Appendix J Comments on the Initial Study/Environmental Assessment

In August 2010, the California Department of Transportation (Department), in cooperation with the San Mateo County Transportation Authority (SMCTA), circulated the *US 101/Broadway Interchange Reconstruction Project Initial Study with Proposed Mitigated Negative Declaration/Environmental Assessment (IS/EA)* for public review. This appendix presents a description of the public review process and a summary of prevalent comment topics; the public comments received on the IS/EA via e-mails, letters, comment cards, and testimony received during the public meeting; and the responses to those comments.

R-1-1

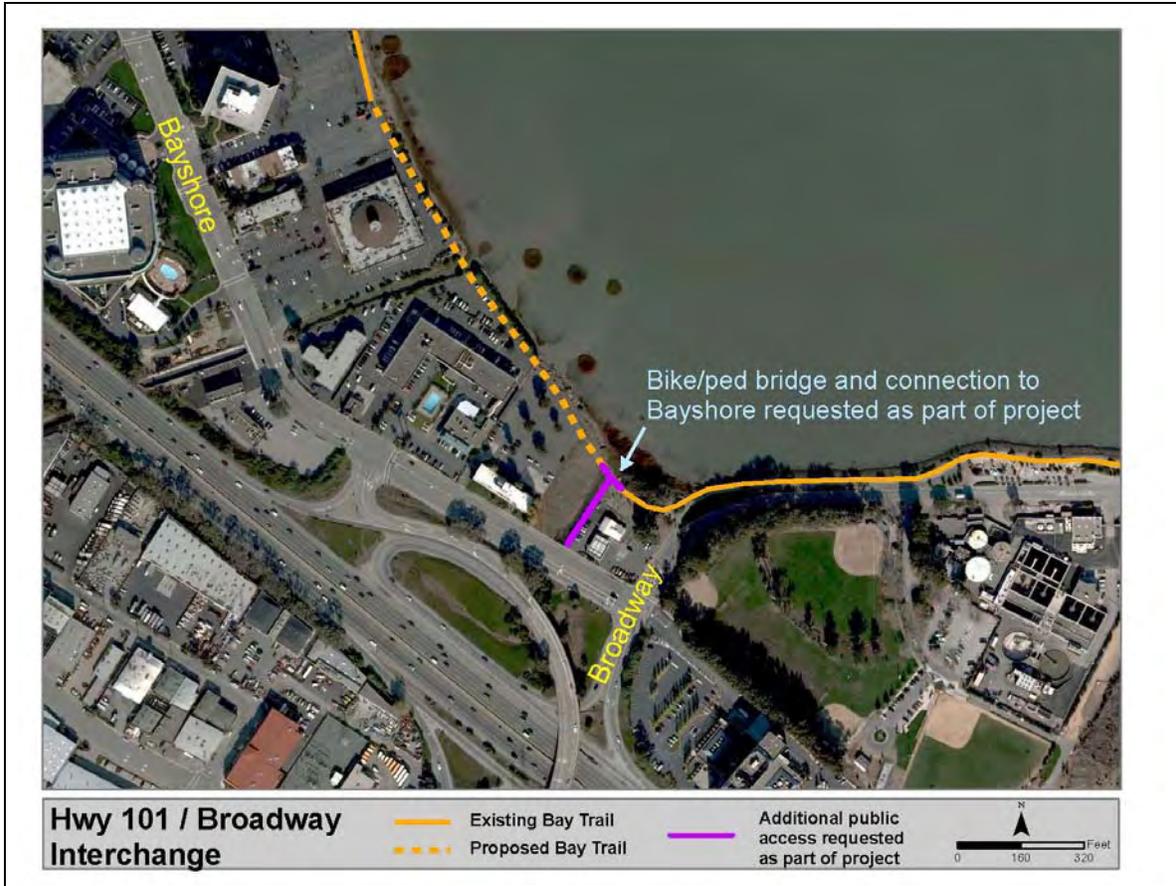
Just as Caltrans seeks to improve links in the regional highway transportation system through this project, we request that links in the regional bicycle and pedestrian network also be completed. To improve functionality of the trail and complete a critical trail gap within the interchange reconstruction project area, we request the addition of two components to the project: 1) extend the trail turnaround by bridging the "unnamed channel", and 2) construct a new a bicycle/pedestrian path connection to Bayshore Boulevard to ensure continuous travel along the Bay Trail. Bay Trail marker and way-finding signs should also be installed. See the attached map for details.

The proposed bridge and path connection described in the comment would not be needed to avoid, minimize, and/or mitigate effects from the project. Nonetheless, the Department and SMCTA can further explore the proposed components during the detailed project design and permitting phases. A bridge over the unnamed drainage channel and a new bicycle/pedestrian connection to Bayshore Highway through the vacant lot would have to be evaluated in conjunction with a number of environmental and engineering factors, including the following:

- The outcome of formal consultation with the U.S. Fish and Wildlife Service (USFWS) regarding federally listed endangered species habitat in and near the unnamed drainage channel;
- The outcome of formal consultation with the USACE regarding the channel, which is a tidal salt marsh wetland;
- The potential use of the vacant lot just north of the Bay Trail turnaround for wetland mitigation/restoration;
- The elevation change between Bayshore Highway along the west side of the vacant lot, which will be approximately 8 to 10 feet higher than the ground surface of the vacant lot;
- Design requirements for the proposed Bay Trail connector, including Bay Trail, Department, and Americans with Disabilities Act (ADA) requirements;
- Design requirements to accommodate sea level rise, as presented in BCDC's proposed Bay Plan amendments; and
- Long-term maintenance and ownership.
